#### RESERVE AT HIDDEN LAKE-FINAL DRAINAGE PLAN REVISIONS

## Hidden Lake-Revisions to Final Drainage Plan

Re: The Reserve at Hidden Lake Vanderburgh County Surveyor Comments Morley Project # 8716.4.002-B

Option 2 Plan and **Profile**

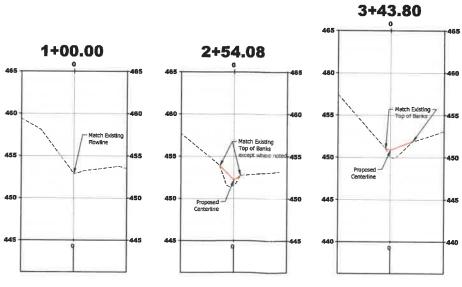
- 4. The locations, cross sections, and profiles of existing streams, floodways, and floodplains to be maintained, and the same for all new channels to be constructed; What direction does Swale S-3, S-6 and EO-3 flow? See also 13.04.180C Flow arrows have been added

- c. Pipe 1008 is existing and will not be altered as a part of the proposed amendments.
- 15. 13.04.180 C: We have added plan and profiles for Swales S-4, 6 and 7. Refer to Sheets C-107 and C-108. A typical swale cross section can be found on Sheet C502A.
